Staff Report

To: Salt Lake City Planning Commission
From: Eric Daems, Senior Planner, eric.daems@slcgov.com or 801-535-7236
Date: March 9, 2022
Re: PLNPCM2021-01109 (Planned Development) PLNPCM2021-01150 (Design Review) for Liberty Duet Apartments

PLANNED DEVELOPMENT & DESIGN REVIEW

A request by Zack Jones of Cowboy Partners for **Design Review** and **Planned Development** review at approximately 353 East 500 South. The proposal is for a 54-unit, 5 story, multi-family development. The building is proposed to be 60' in height and is located in the R-MU-45 zone. The development is seeking approval for additional building height and for relief from site development standards of the R-MU-45 zone. The specific request to the Planning Commission is for the following:

500 SOUTH STREET ELEVATION

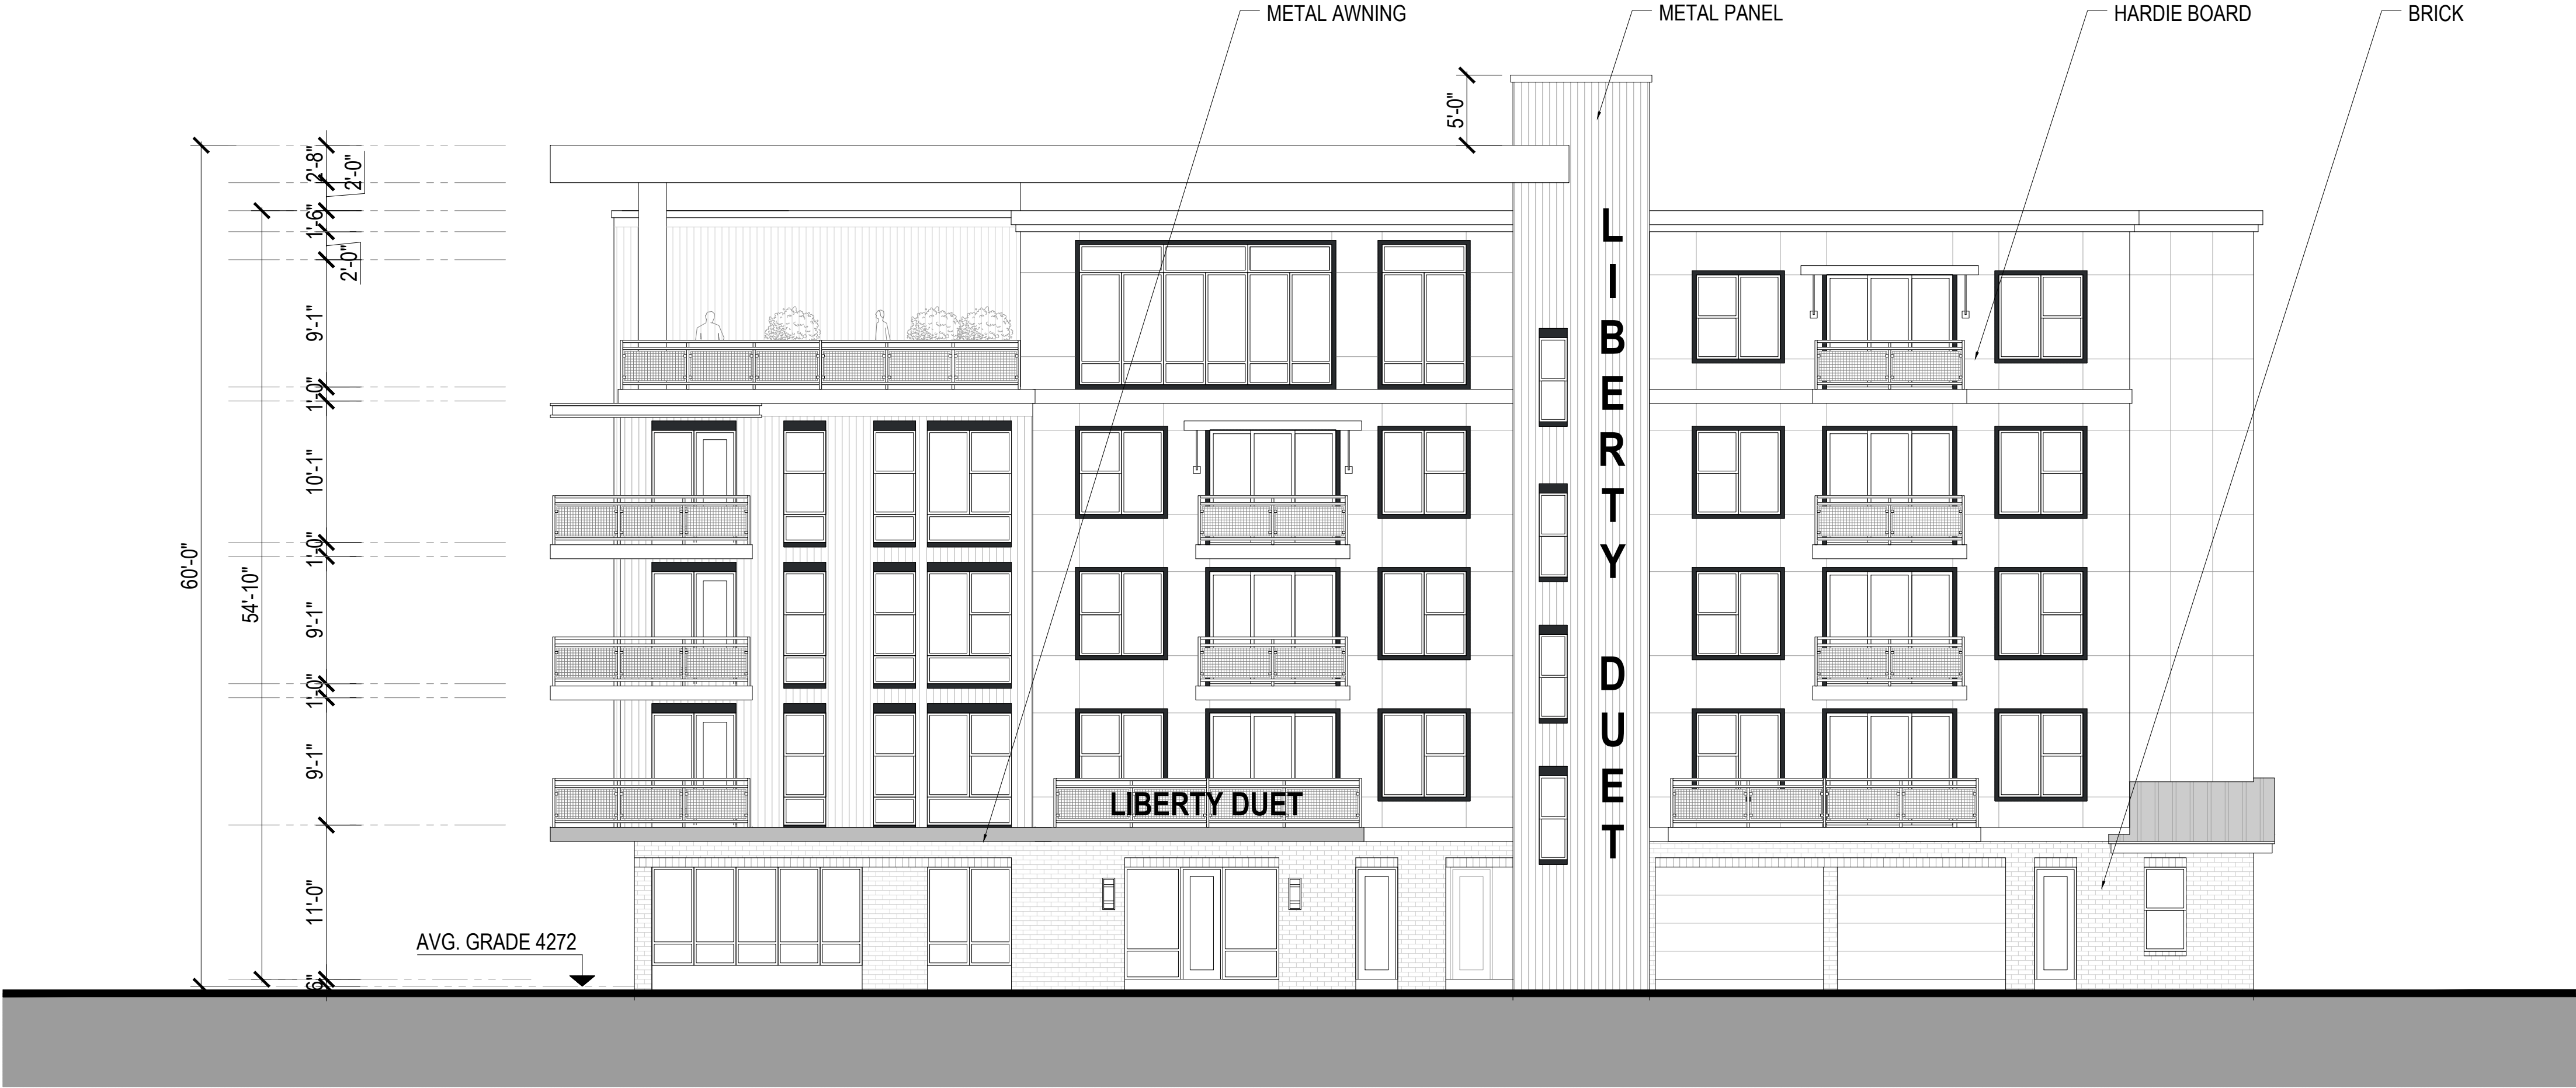
1. The garage doors include transparent panels for at least 50% of the width between 3' and 8' feet from the ground.
2. The parcels be combined prior to beginning construction.
3. Final approval for signage be delegated to Staff to review in accordance with adopted standards and ordinances.

<p>C. Building facades shall include detailing and glass in sufficient quantities to facilitate pedestrian interest and interaction.</p> <ol style="list-style-type: none"> 1. Locate active ground floor uses at or near the public sidewalk. 2. Maximize transparency of ground floor facades. 3. Use or reinterpret traditional storefront elements like sign bands, clerestory glazing, articulation, and architectural detail at window transitions. 4. Locate outdoor dining patios, courtyards, plazas, habitable 	<p>Complies with Staff Recommendation</p>	<p>The proposed building uses a rich mix of materials along the ground level including glass, brick, and metal. In addition, the ground floor exterior will include planter boxes and interesting lighting to enhance interaction at the pedestrian level.</p> <ol style="list-style-type: none"> 1. The ground floor includes a fitness center, leasing office, and a lobby. All include large glass windows and doors. 2. Transparency is maximized on ground floor facades with large windows and visibility into the lobby, leasing office, and additional amenity spaces along 500 South. The biggest limitation to glass along the 500 South frontage is the space needed for the driveway. It is required to be along 500 South as Blair Street is restricted to access for public safety vehicles only. Staff is recommending some glass panels be included in the garage door to bring

PROJECT:	
DRAWN BY:	
CHECK BY:	RDL
ISSUE DATE:	01-21-22
REVISIONS:	X-X -X-X -XX
SHEET TITLE	
Landscape Planting Plan	
SHEET NUMBER

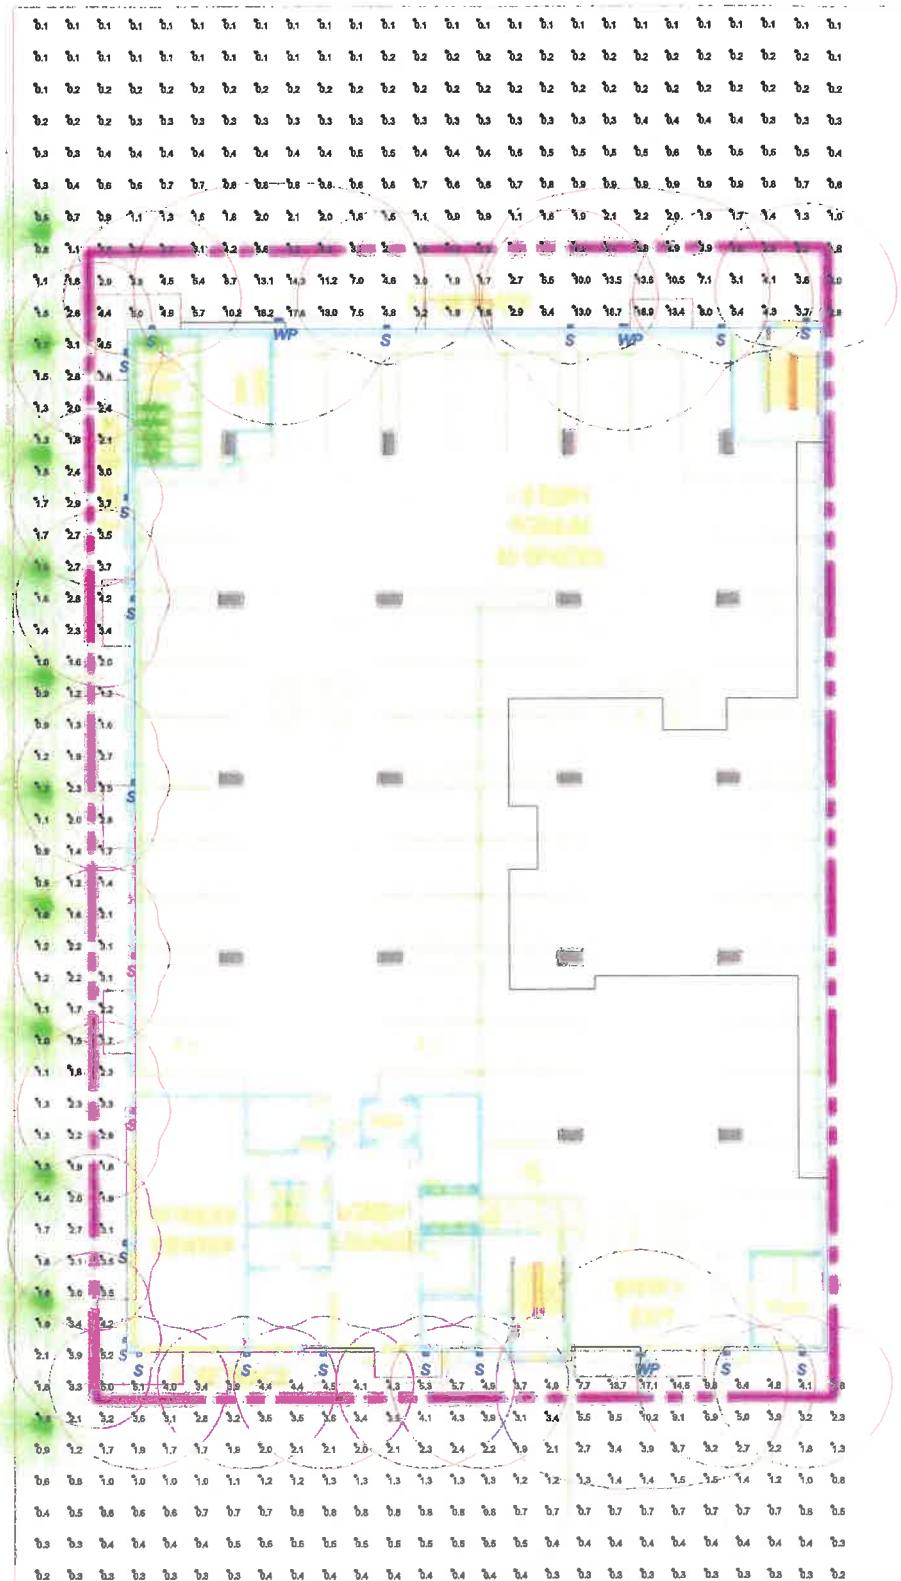
Though not specifically stated on the plans. It appears that they intend to remove all existing trees on the property including the two Public ROW Maple trees on 500 S and replace them with three little 2" Zelkova. The currently existing Maples already have an established and functioning canopy that should be preserved. It appears that with relatively small design adjustments that both of the existing trees could be preserved to allow for many years of preserved benefits from these long established trees.

Staff Response: Efforts will be made to preserve the trees. If they cannot be preserved, mitigation fees for the removed trees will be required to be paid prior to the issuance of a building permit.
